SHEARON HARRIS NUCLEAR POWER PLANT
UNIT NO. 1 - DOCKET NO. 50-400
CONTAINMENT PURGE AND VENT VALVE OPERABILITY REVIEW

REFERENCE: NRC Letter Dated October 30, 1985, G. W. Knighton to Mr. E. E. Utley,
Request for Additional Information

SHEARON HARRIS NUCLEAR POWER PLANT PURGE AND VENT VALVE OPERABILITY (TMI II.E.4.2(6)) NRC REQUEST FOR ADDITIONAL INFORMATION

Graph of the Value of the
Dynamic Torque and the Operator
Closing (Spring) Torque at
Different Yoke Arm Angles

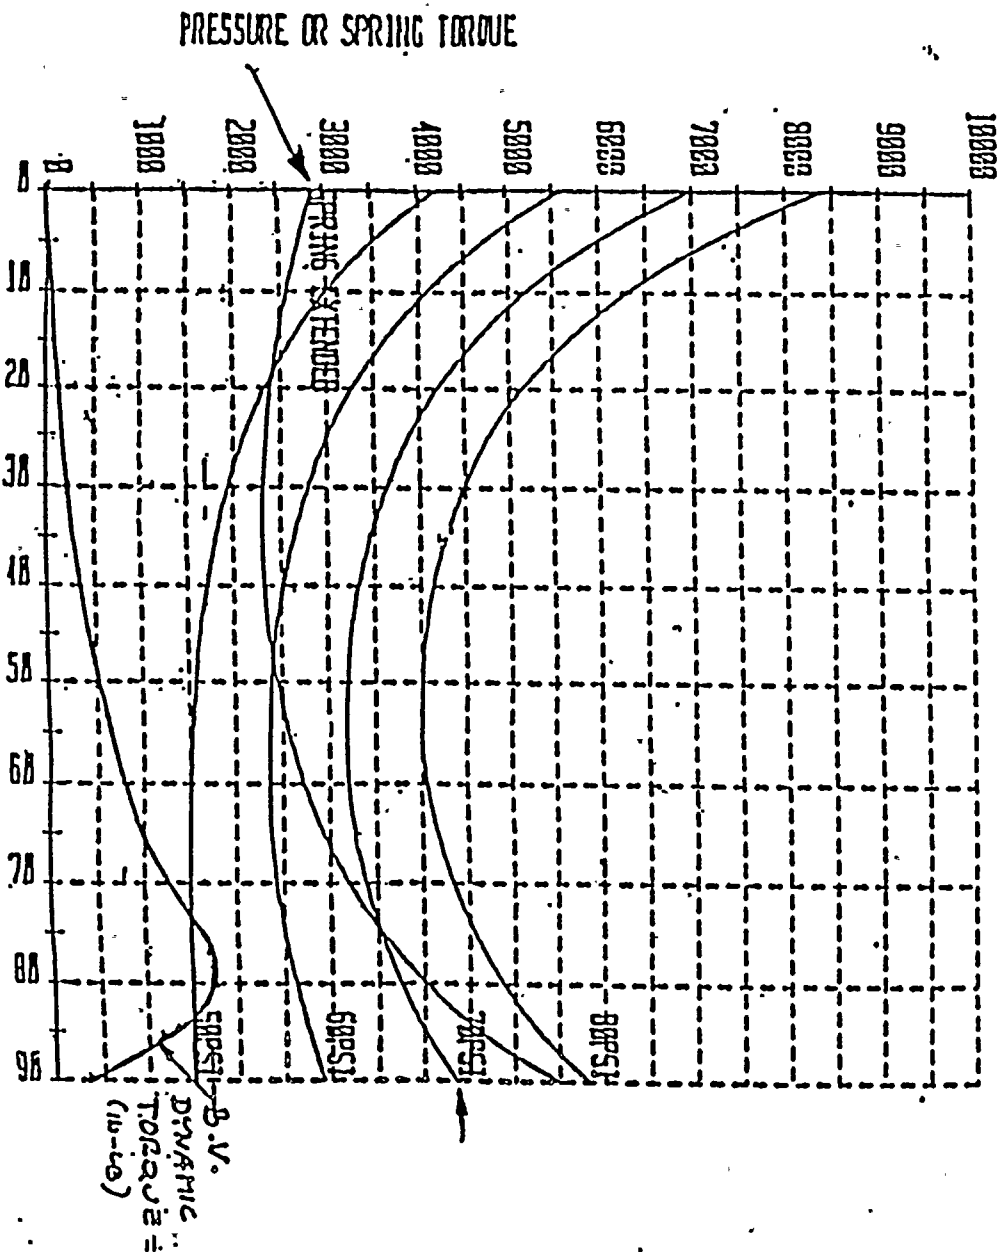
The torque capacity of the Bettis actuator model N721C-SR60-12 is given as 2570 in-lb without reference to valve disc angle, minimum and maximum torque available, and torque available for reduced power source. (Page 41 of BIF Dynamic Torque Calculation.)

The applicant should provide the actuator torque curves versus valve opening angle in tabular or graphic form. The applicant should compare the available torque of the operator with the maximum torque required to operate the valves during the accident scenario.

Referring to the fact that valve dynamic torque generated by the effluent flow (Accident Scenario) is acting unidirectionally with the operator closing torque generated by the operator spring action, a relative torque will be imposed on the actuator by the valve and not vice versa. The maximum valve dynamic torque indicated in BIF report is 1731 in-lb while the operator minimum closing (spring) torque is 2319 in-lb. The attached graph (Attachment B) shows the value of the dynamic torque and the operator closing (spring) torque at different yoke arm angles. The graph indicates that the operator torque capability is always higher than the valve dynamic torque thus preventing the valve from sudden closure. In reality, the speed at which the valve will close depends mainly on how fast the operator piston will travel during the closing cycle which in turn depends on the solenoid valve size and its air pressure drop characteristics through its exhaust port. The valve dynamic torque may increase slightly the valve closing speed but not to an appreciable value.
